BID ADDENDUM NO. (2)

3/5/26

Prattsburgh Central School District
2025 Capital Improvements Project
2716-043

The following Addendum items shall be considered a part of the contract documents prepared by HUNT ENGINEERS, ARCHITECTS, LAND SURVEYORS & LANDSCAPE ARCHITECT, DPC. Bid Document date of (12/18/2025).

① SECOND FLOOR PIPING PLAN MODIFICATIONS
 1/8" = 1'-0"

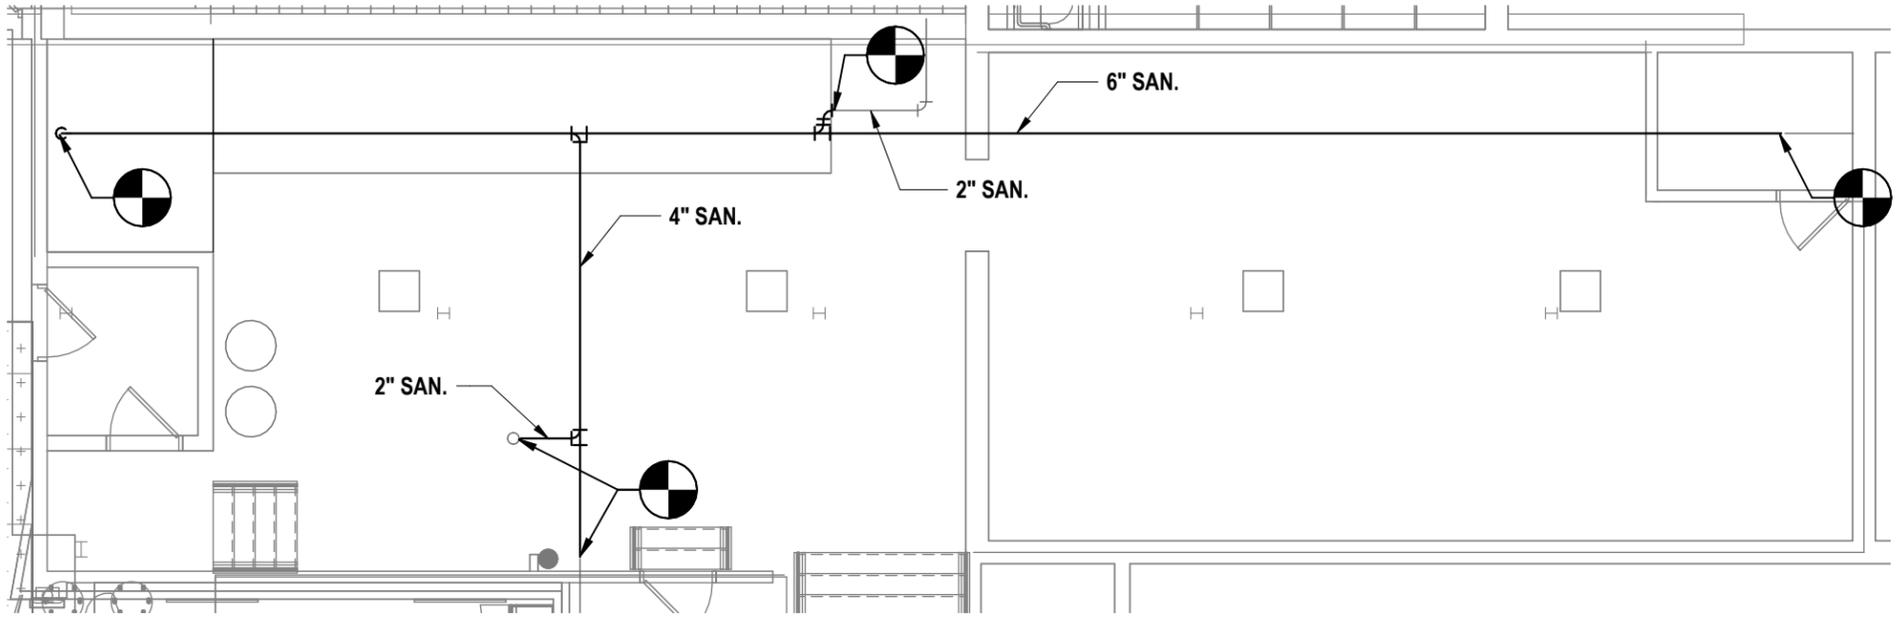
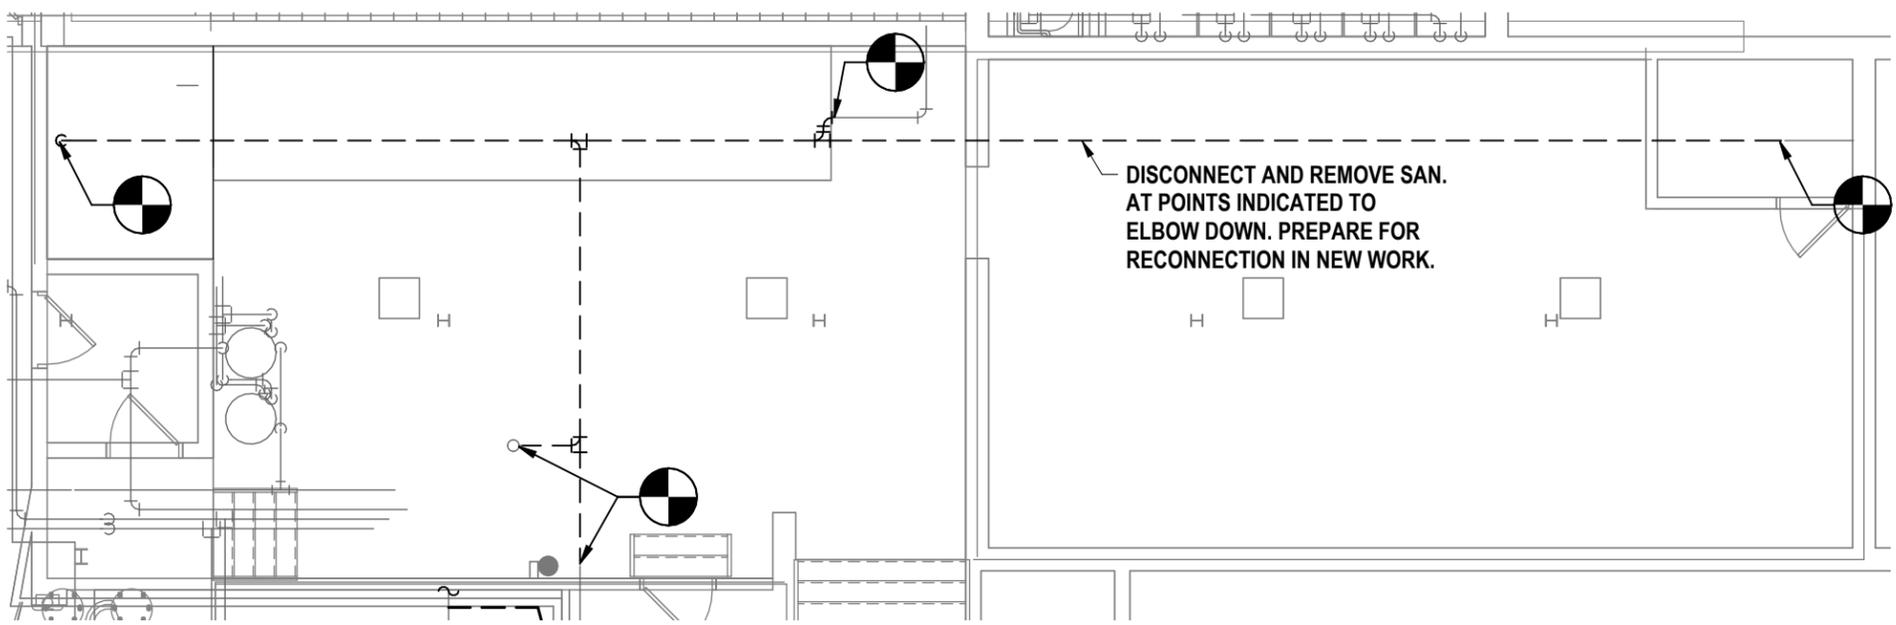
ITEM AD2-29 Refer to Drawing MB-H2.3 – SECOND FLOOR PIPING PLAN

AMEND Detail #1 as shown on AD2-H3 – SECOND FLOOR CONDENSATE SIZING as issued by this addendum.

1 BOILER ROOM DEMOLITION PLAN
 1/8" = 1'-0"

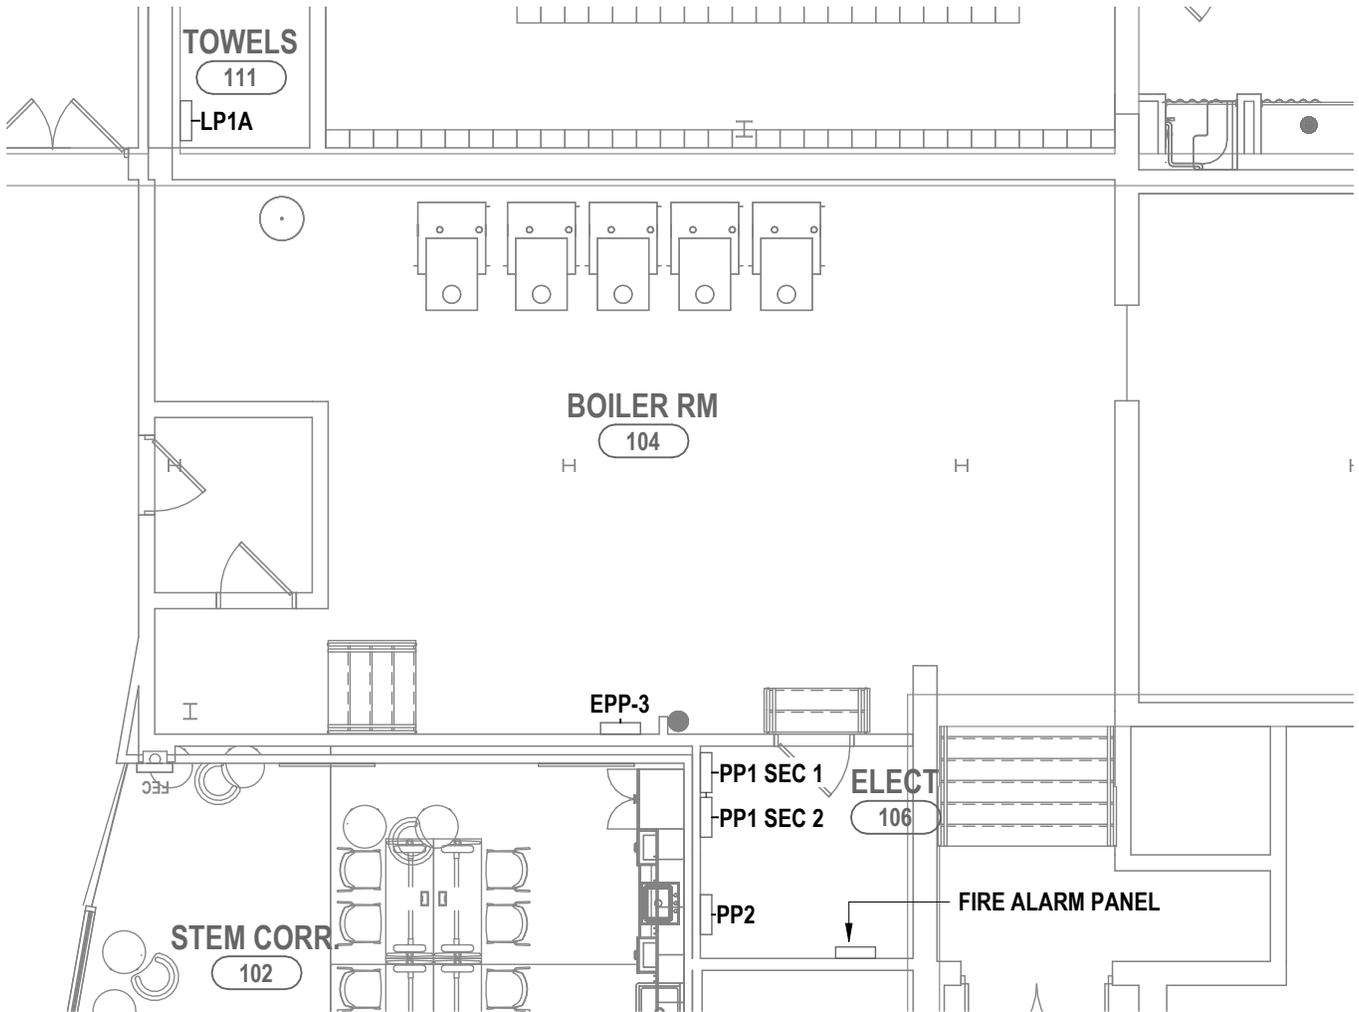
ITEM AD2-31 Refer to Drawing MB-P1.1 – FIRST FLOOR SANITARY PLANS

ADD Detail #1 as shown on AD2-P1 – BOILER ROOM PLANS as issued by this addendum.

① **GROUND FLOOR AREA A - FA PANEL LOCATION**
 1/8" = 1'-0"

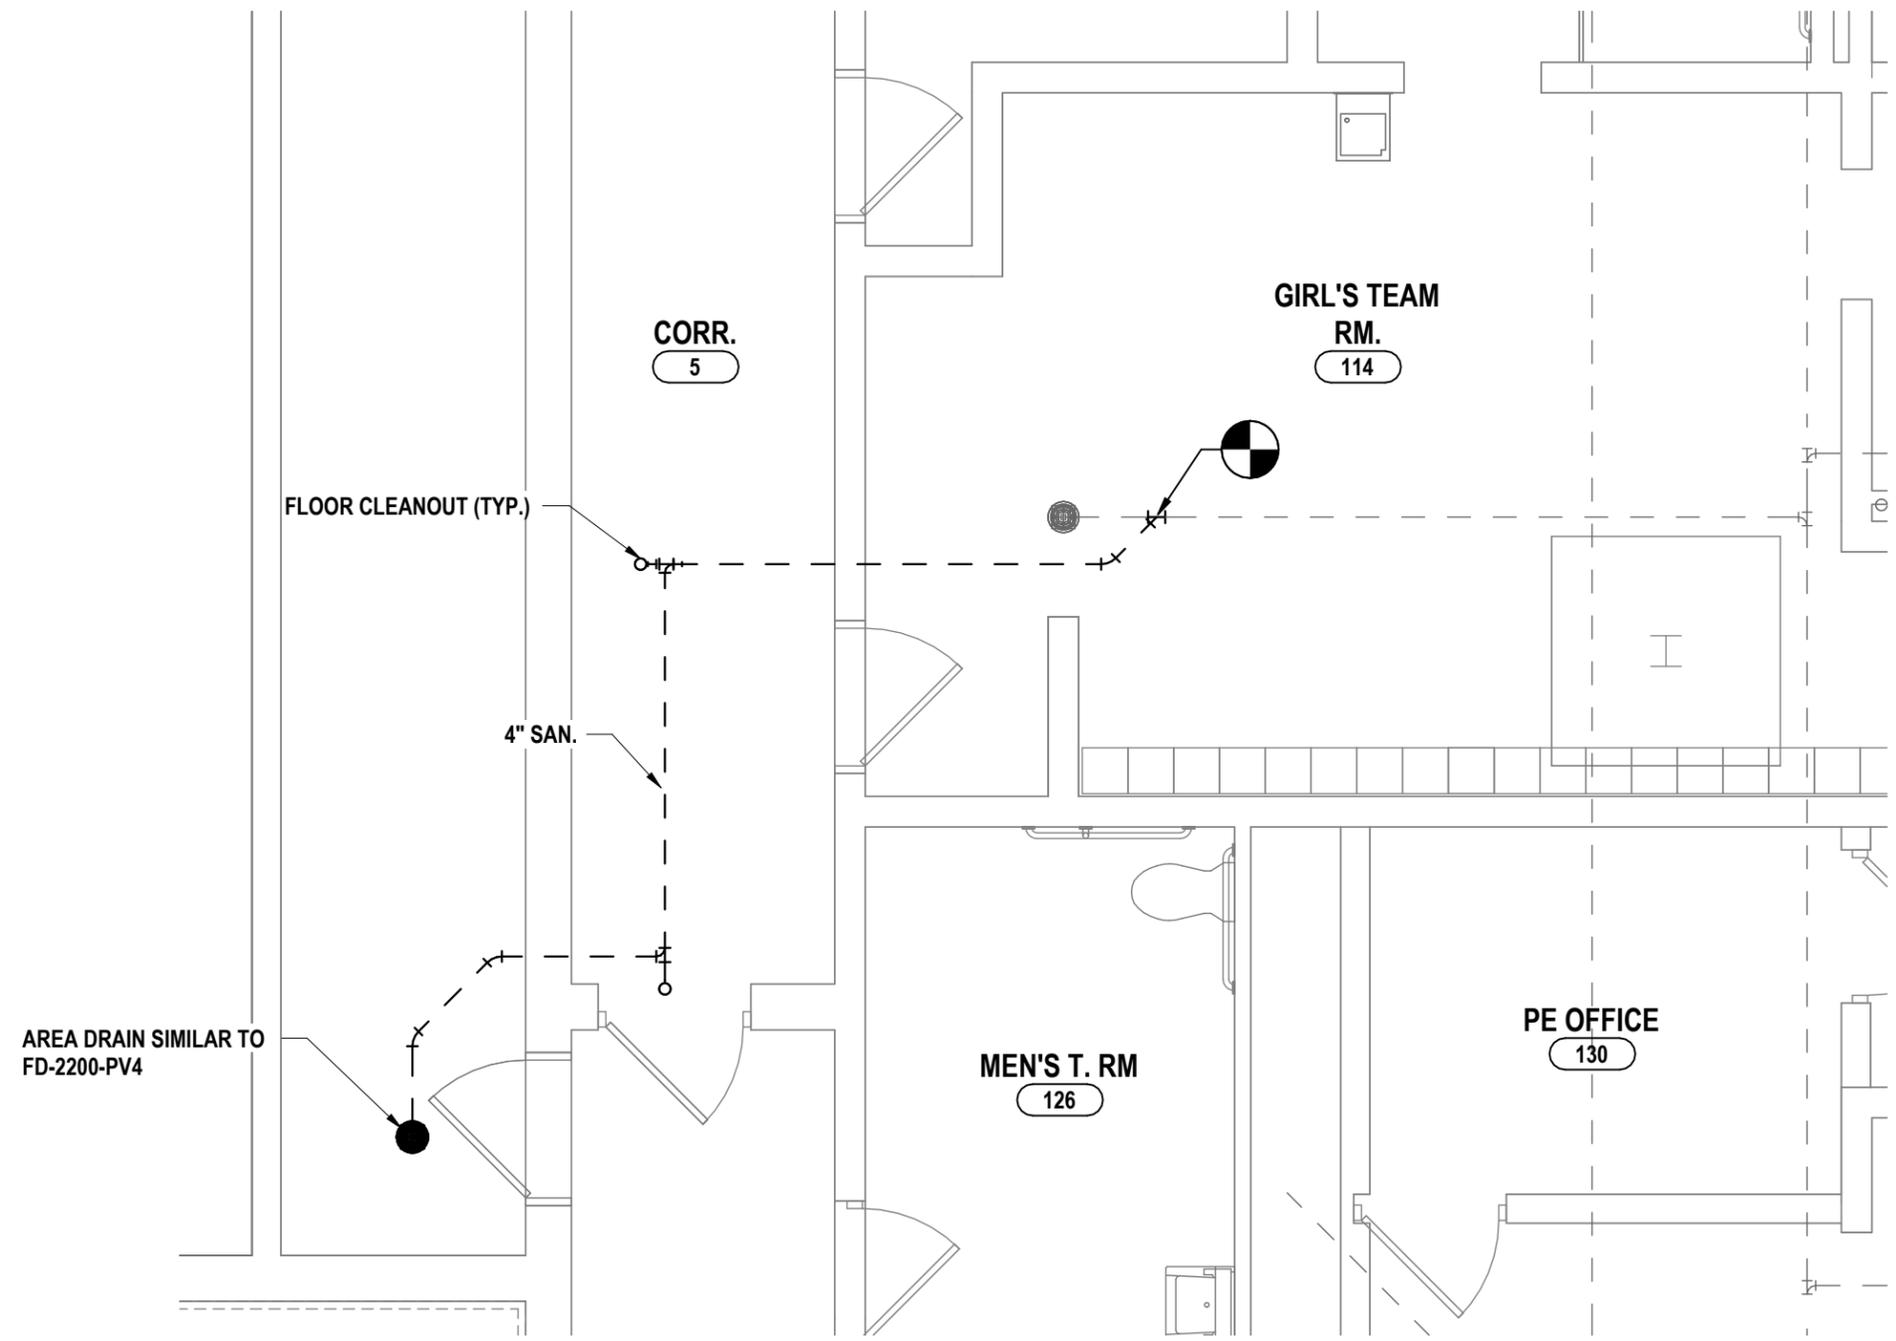
ITEM AD2-43 Refer to Drawing MB-E1.2 – GROUND FLOOR POWER PLAN AREA A

ADD Sheet AD2-E1 – FA PANEL LOCATION

1 GROUND FLOOR SANITARY PLAN - AREA A
 1/4" = 1'-0"

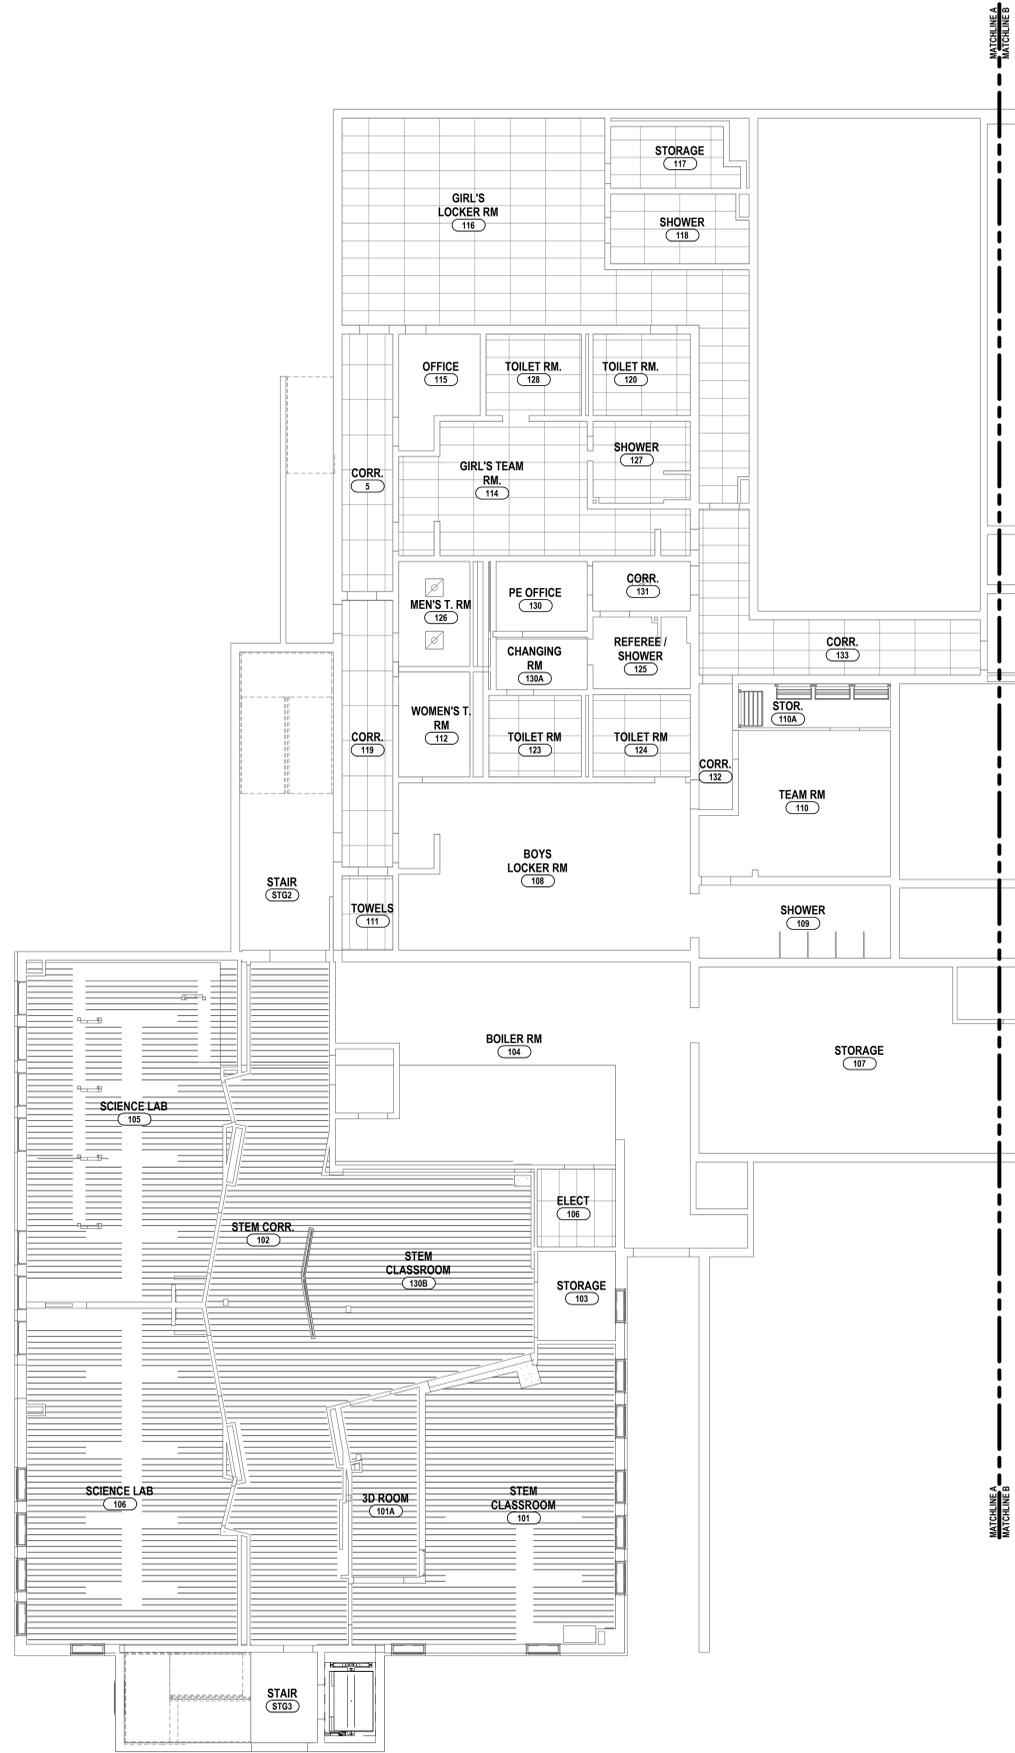
ADD Detail #1 as shown on AD2-P2 – GROUND FLOOR SANITARY PLAN – AREA A
